**RESOLUTION SETTING HEARING ON REQUEST FROM KADING PROPERTIES, LLC. (OWNER), REPRESENTED BY KARIE RAMSEY (OFFICER), FOR REVIEW AND APPROVAL OF THE 9TH AMENDMENT TO THE MEADOWLANDS PUD CONCEPTUAL PLAN, 2100 MEADOW COURT**

Kading Properties, LLC. (owner) represented by Karie Ramsey (officer) on property at 2100 Meadow Court.				File #		
				ZON2014-00178		
Description of Action		Approval of the 9th Amendment to the Meadowlands PUD Conceptual Plan to revise the proposed configuration of residential dwellings on 2100 Meadow Court from 43 units within rowhouses having rear loaded garages to 34 units within two family dwellings having front loaded garages subject to revisions.				
2020 Community Character Plan		Current: Medium Density Residential. Proposed: N/A.				
Horizon 2035 Transportation Plan		No planned improvements.				
Current Zoning District		"PUD" Planned Unit Development.				
Proposed Zoning District		N/A.				
Consent Card Responses		In Favor	Not In Favor	Undetermined	% Opposition	
Inside Area		2	3			
Outside Area						
Plan and Zoning Commission Action		Approval	11-1	Required 6/7 Vote of the City Council	Yes

Communication from the City Plan and Zoning Commission advising

CONCEPT PLAN

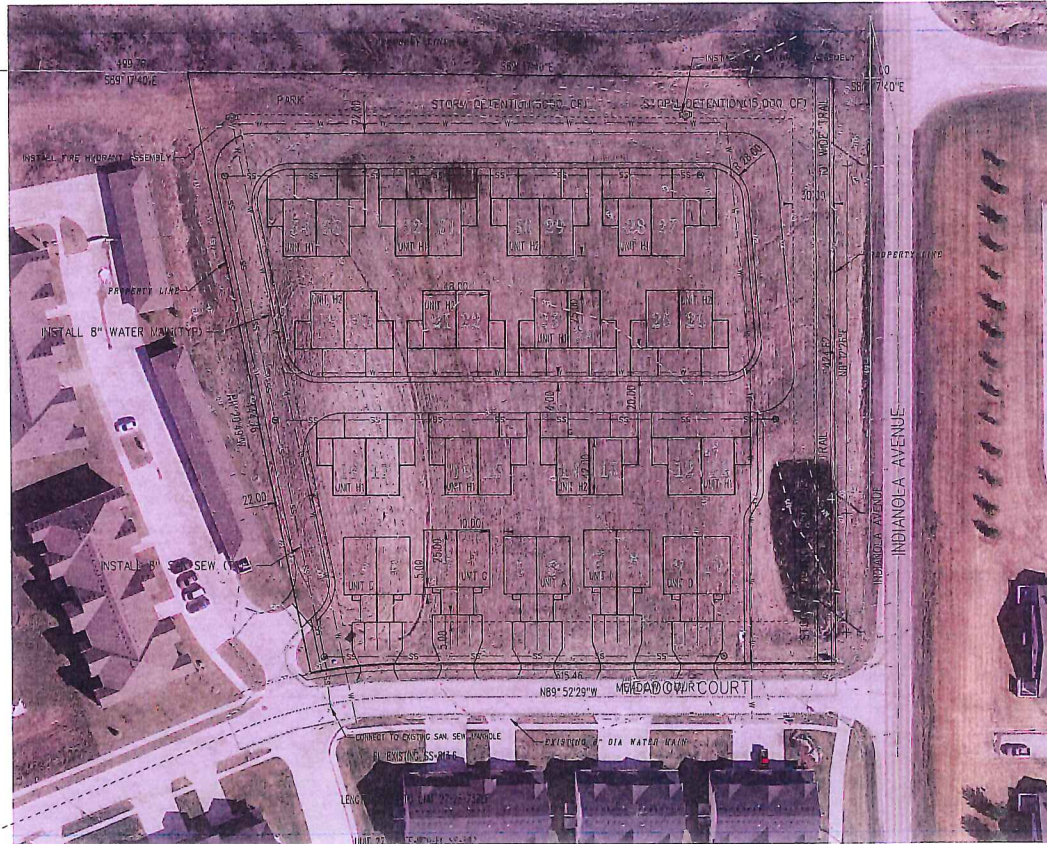
1. Conformance with all administrative review comments by the Permit and Development Center.
2. Sheets 1 and 3 shall be revised to reflect the configuration proposed on Sheet 2.

8. Provision of at least one (1) overstory tree in front of each two-family structure.
9. Provision of landscaping within the 5-foot paving setback along the west property line to the satisfaction of the City’s Planning Administrator.

10. The plantings within the northern portion of the site shall be spread out to provide an adequate buffer along the north property line to the satisfaction of the City’s Planning Administrator.

11. Relocation of the proposed private park to a more central location within the development that is more accessible and visible to residents, to the satisfaction of the City’s Planning Administrator. This may result in the loss of a dwelling unit.

Sheet No.  
2 of 3  
Unit Type D  
Elevations

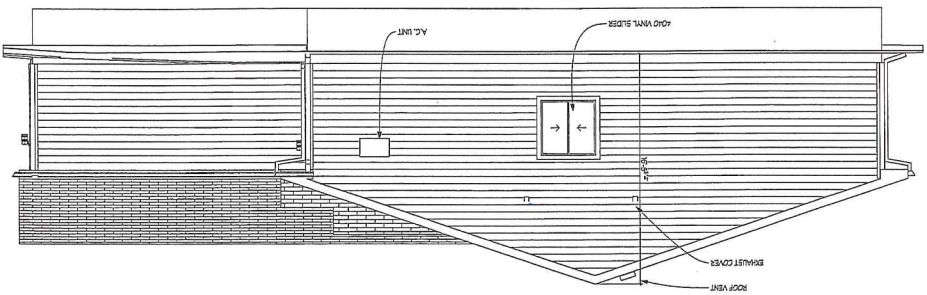
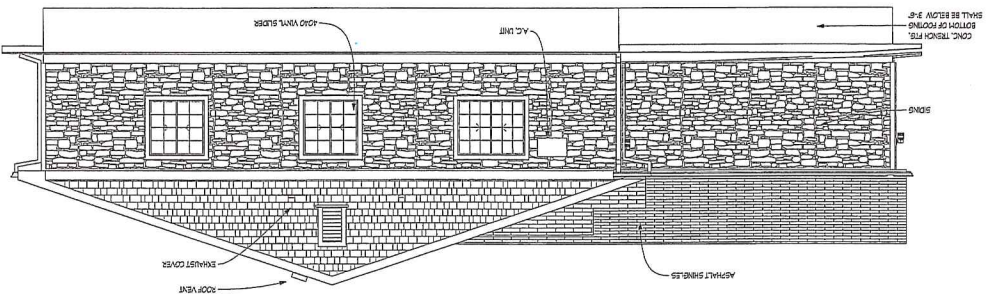
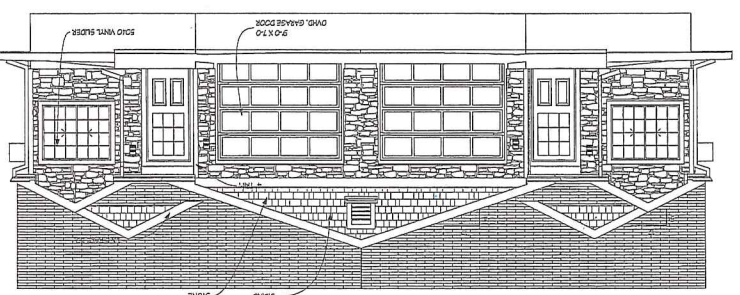
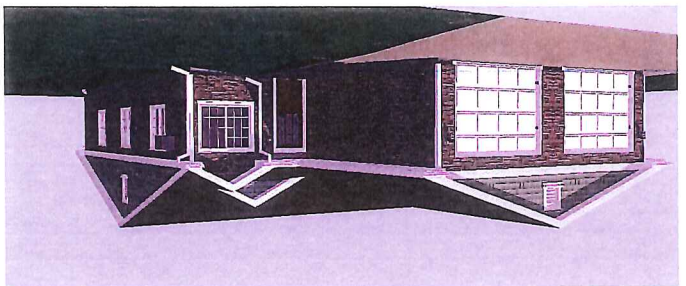
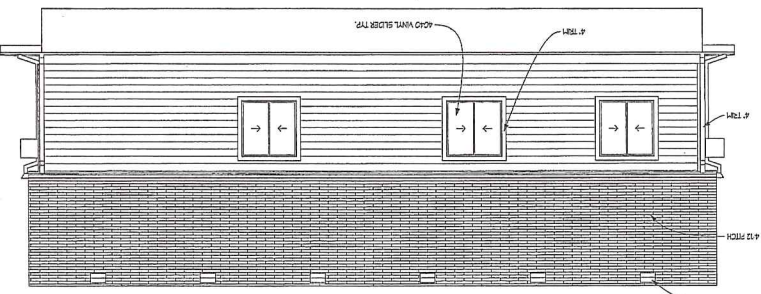
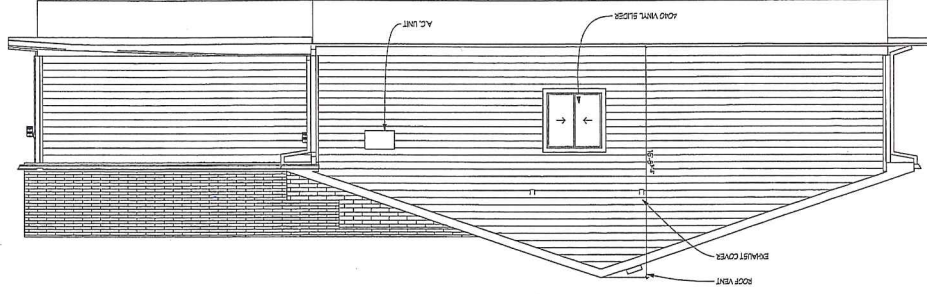
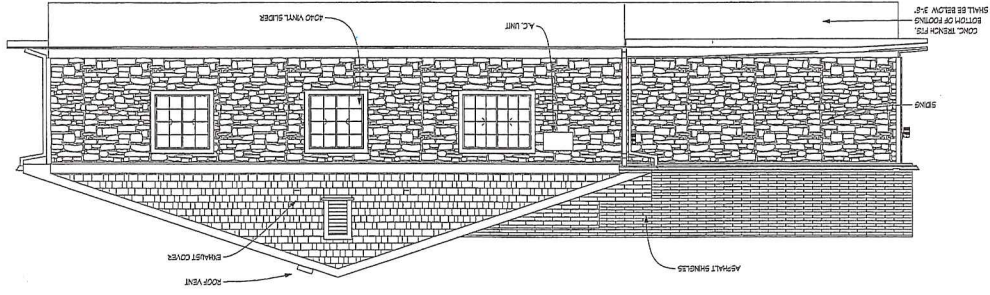
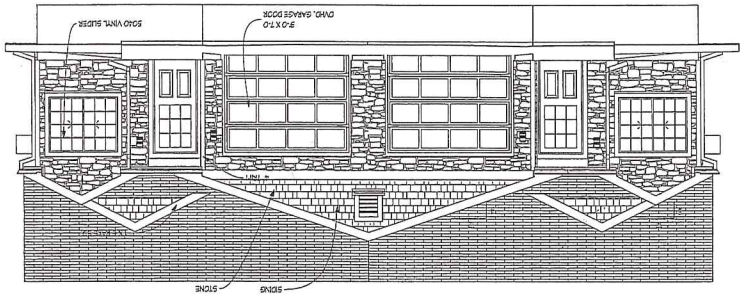
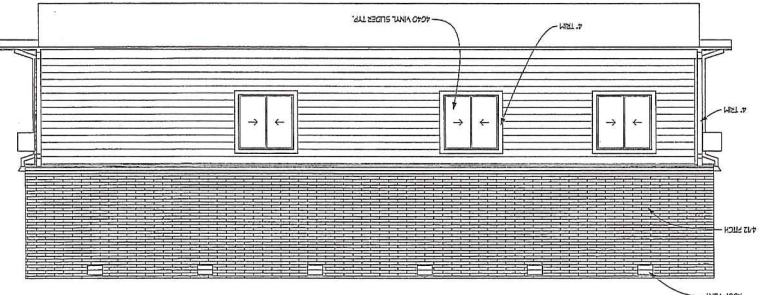
4. Provision of a sidewalk connection to the recreational trail along the east edge of the site.
5. The two building designs labeled as “Unit Type D” shall be relabeled to demonstrate the side facades facing external to the site shall consist of stone siding.

The five (5) two-family structures fronting Meadow Court would be differentiated by a mix of four (4) façade types that include varying amounts of stone material, horizontal lap siding, and shake-pattern siding. One of the types includes a front porch feature. The buildings on each end would be a “Unit D”, which includes stone on the most visible sides. Staff notes that the two details for this units are both labeled “Unit Type D”, so they should be revised to “Unit Type D-1” and “Unit Type D-2” to more clearly represent the intent.

Contents  
ELEVATIONS H-2  
OPTION H-2

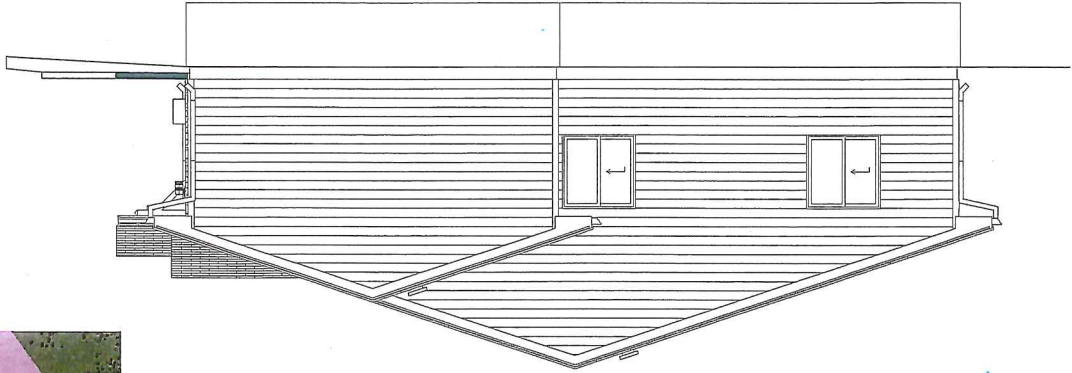
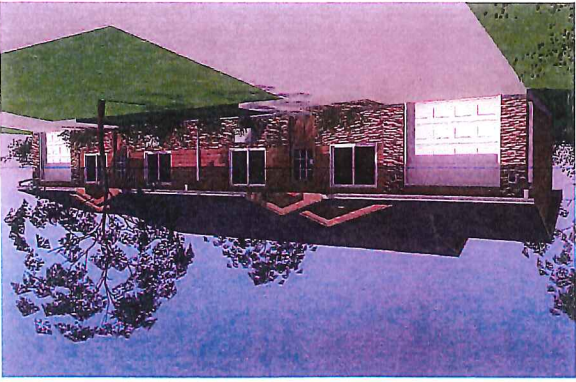
6. The building designs labeled “Option H” and “Option H-2” shall be revised to include a stone wainscot on the highly visible side facades of the furthest east and furthest west units.

The twelve (12) two-family structures fronting the private access road would all be one of two designs that are differentiated by varying amounts of stone material, horizontal lap siding, and shake-pattern siding. Staff recommends that the highly visible side facades of the furthest east and furthest west units include a stone wainscot.

Sheet no.  
Sign

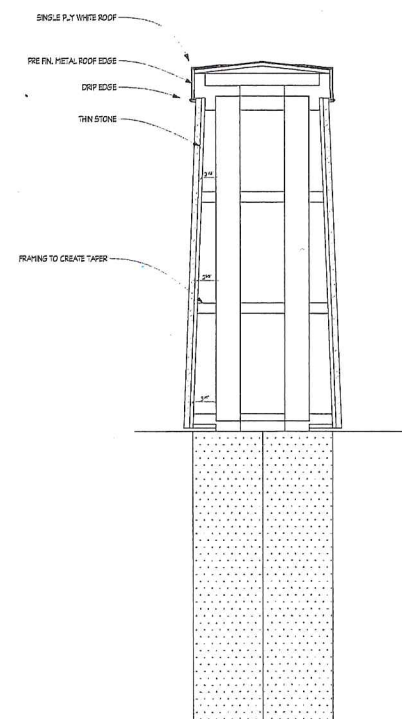
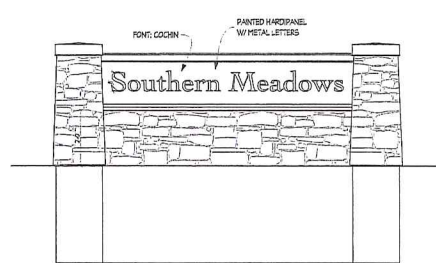
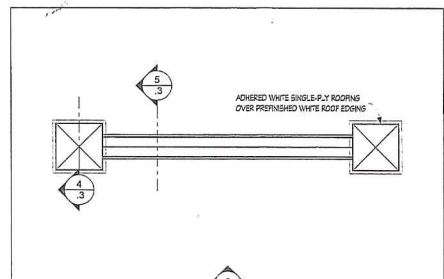
13. The PUD Conceptual Plan shall demonstrate placement of any monument sign to the satisfaction of the City’s Planning Administrator.
14. Provision of a note to state that all outdoor lighting fixtures, including wall-mounted packs and pole lights, shall be low-glare, cut-off type fixtures.
